Corrigendum

Corrigendum to “Two-step co-sintering method to fabricate anode-supported $\text{Ba}_3\text{Ca}_{1.18}\text{Nb}_{1.82}\text{O}_{9-\delta}$ proton conducting solid oxide fuel cells” [Power 215 (2012) 221–226]Siwei Wang^a, Lei Zhang^a, Zhibin Yang^a, Lingling Zhang^a, Shumin Fang^a, Kyle Brinkman^b, Fanglin Chen^{a,*}^a Department of Mechanical Engineering, University of South Carolina, 300 Main Street, Columbia, SC 29208, USA^b Savannah River National Laboratory, Aiken, SC 29808, USA

Fig. 4. (a)

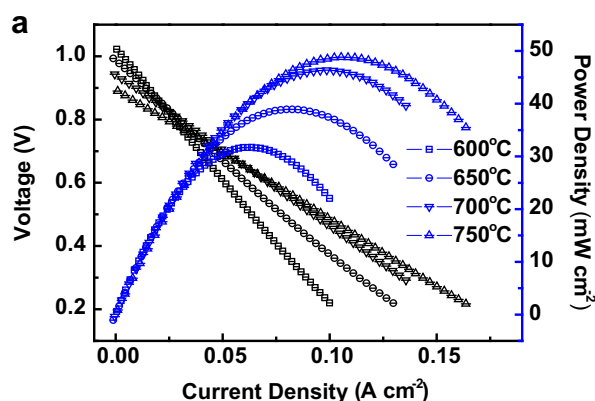
(1) In both Figs. 4(a) and 5(a), the unit of the current density in the X-axis should be (A cm^{-2}), not (mA cm^{-2}).

Fig. 5. (a)

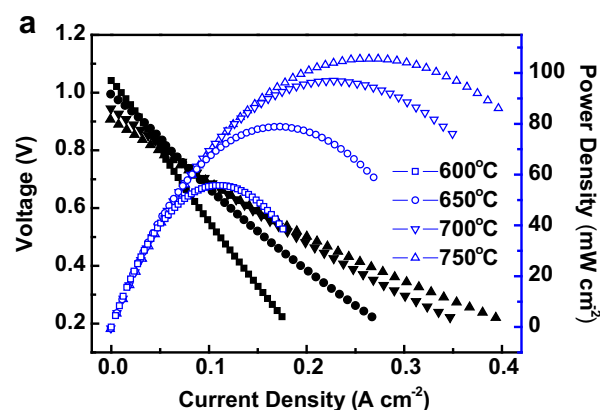
(2) The value in the X-axis in Fig. 5(a) was mistakenly plotted using current, not current density.
